**CS\_CUCHARES\_RANCH GENERATOR ADD**  
**DN03486D BU#: 823518**  
 9285 DRENNEN ROAD  
 COLORADO SPRINGS, CO 80925  
 LATITUDE: 38°46'48.55" N  
 LONGITUDE: 104°39'20.17" W

PROJECT INFORMATION:  
**SITE NAME:**  
 CS\_CUCHARES\_RANCH  
**SITE ID:**  
 DN03486D  
**BU#:** 823518  
 9285 DRENNEN ROAD  
 COLORADO SPRINGS, CO 80925  
 EL PASO COUNTY

# Elevation Plans\_v1.pdf Markup Summary

SHEET NUMBER:  
**T1**

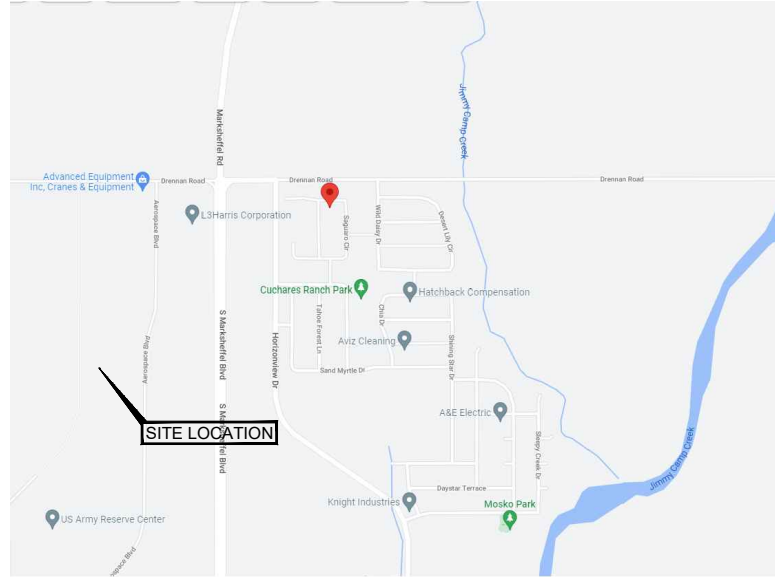
Please include:  
 -legal description of the property (can be found on assessor website)  
 -lot/parcel size

Please include:  
-legal description of the property  
(can be found on assessor website)  
-lot/parcel size

SHEET NUMBER:  
**A1**

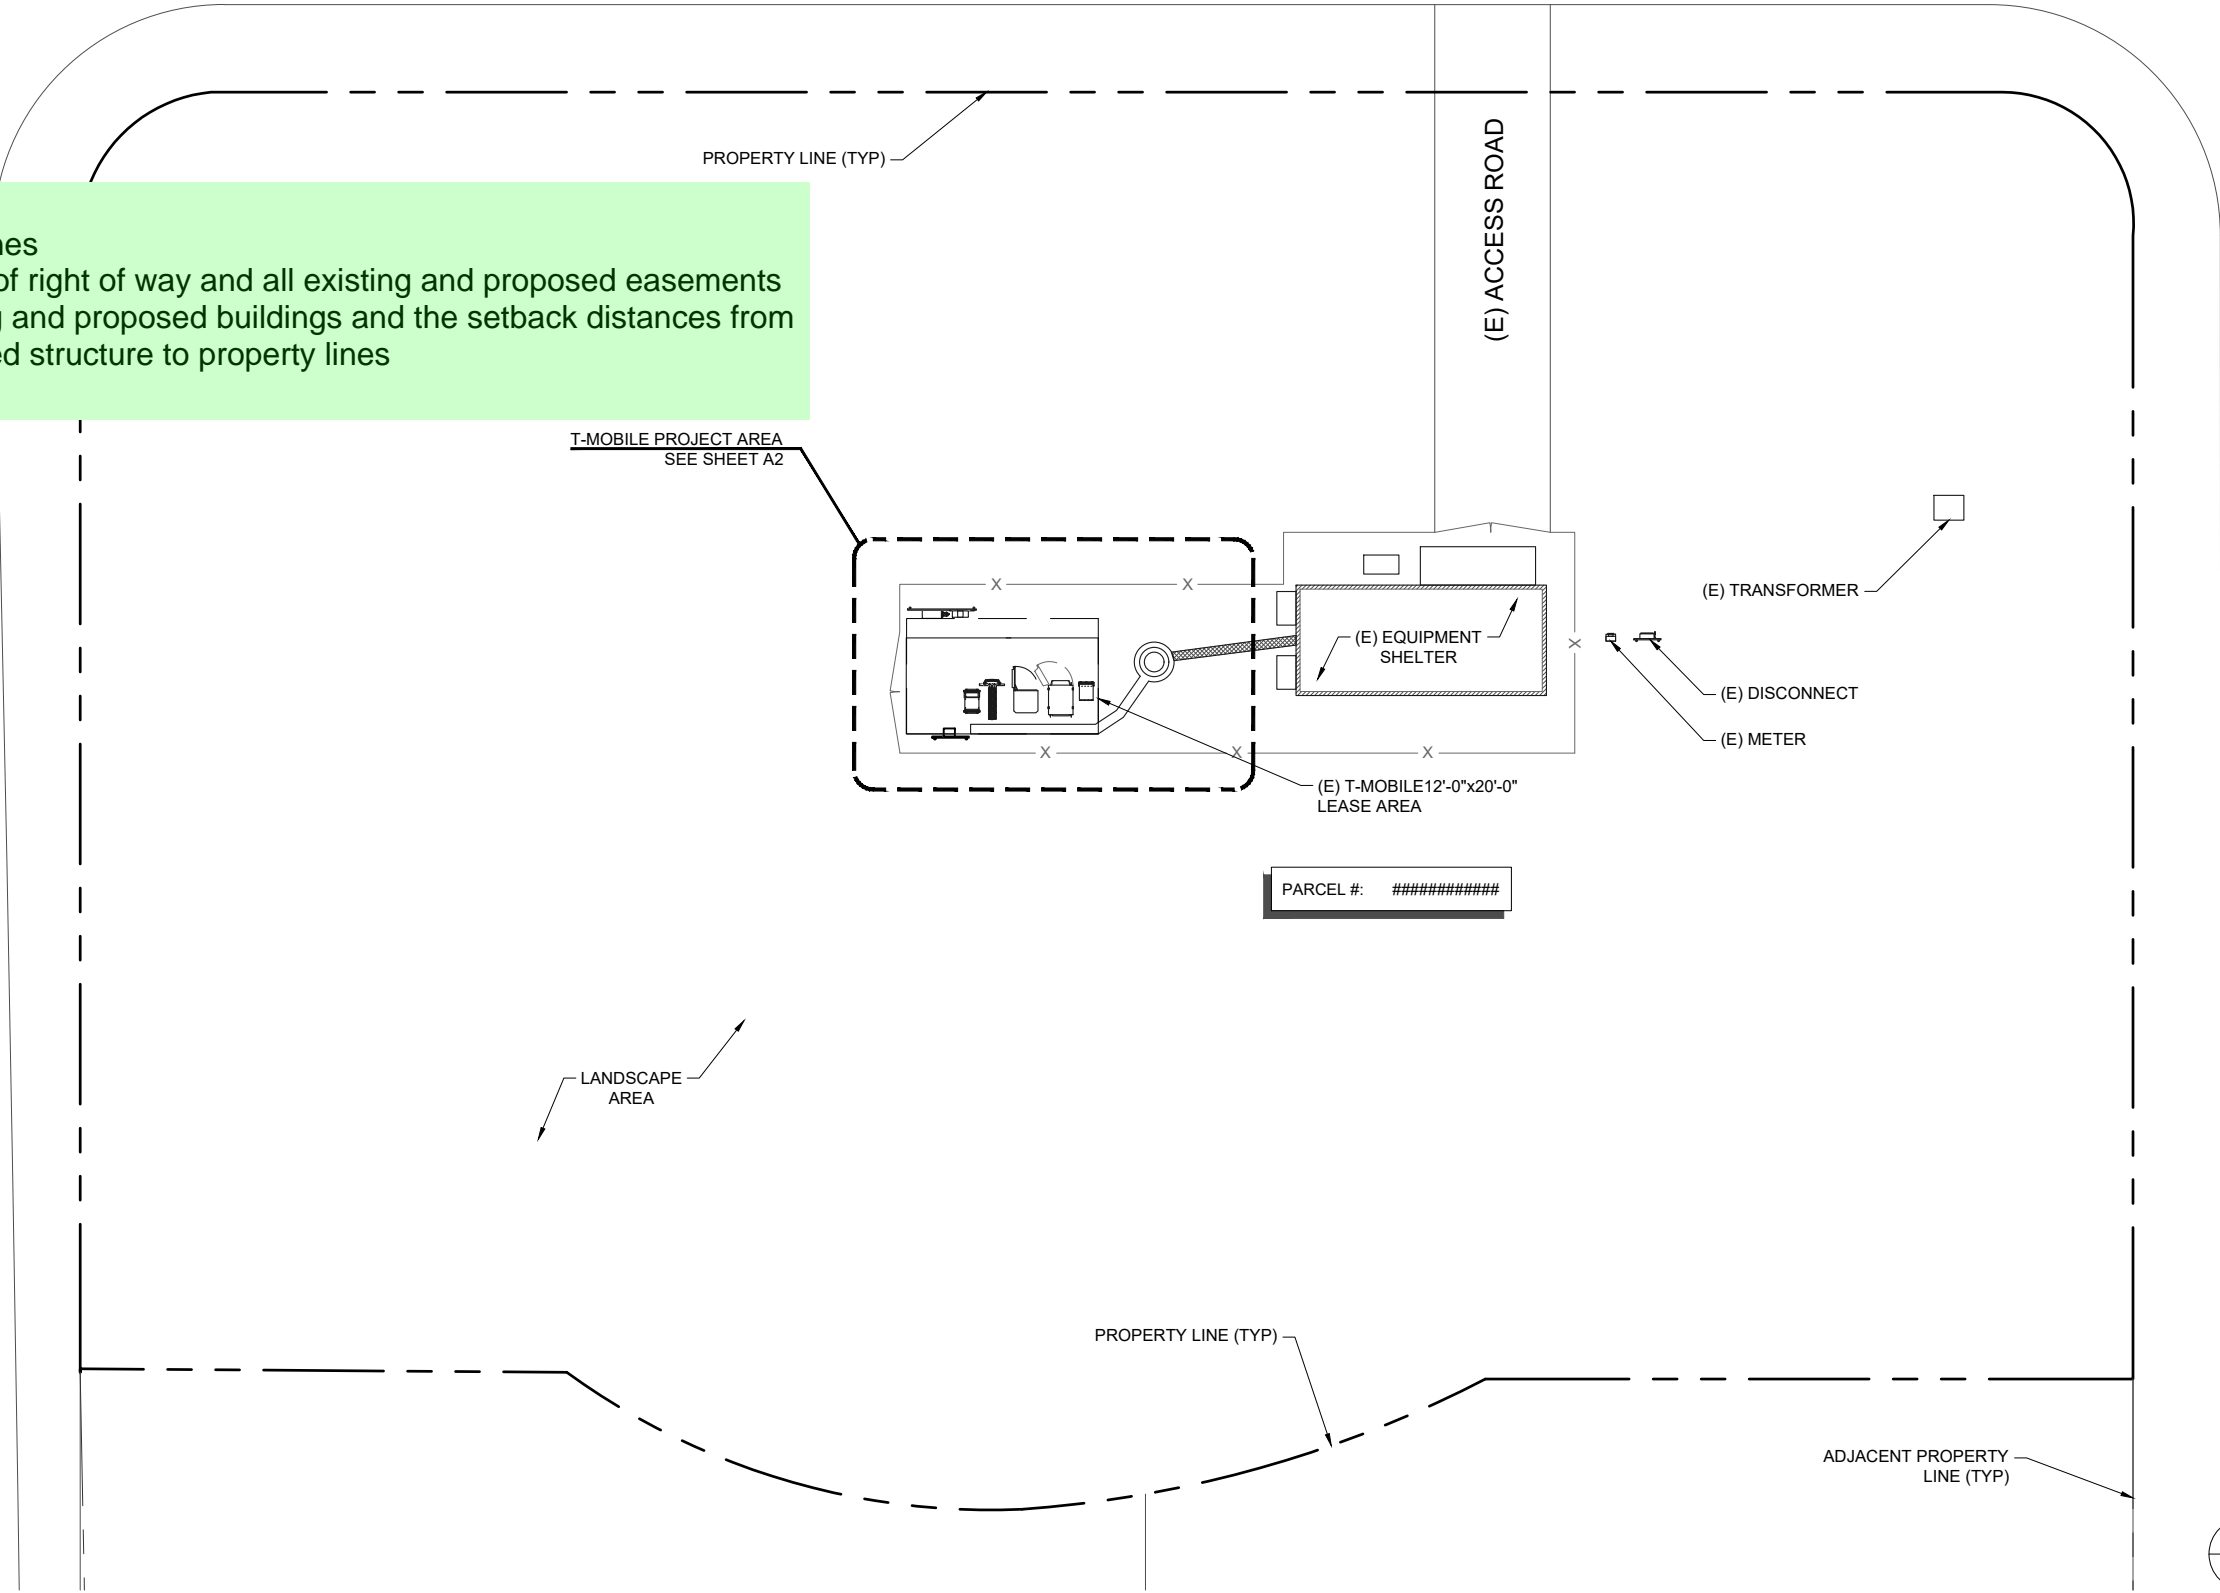
Please include:  
 -dimensions of property lines  
 -location and dimensions of right of way and all existing and proposed easements  
 -the footprint of all existing and proposed buildings and the setback distances from each existing and proposed structure to property lines

Please include:  
-dimensions of property lines  
-location and dimensions of right of way and all  
existing and proposed easements  
-the footprint of all existing and proposed buildings  
and the setback distances from each existing and  
proposed structure to property lines
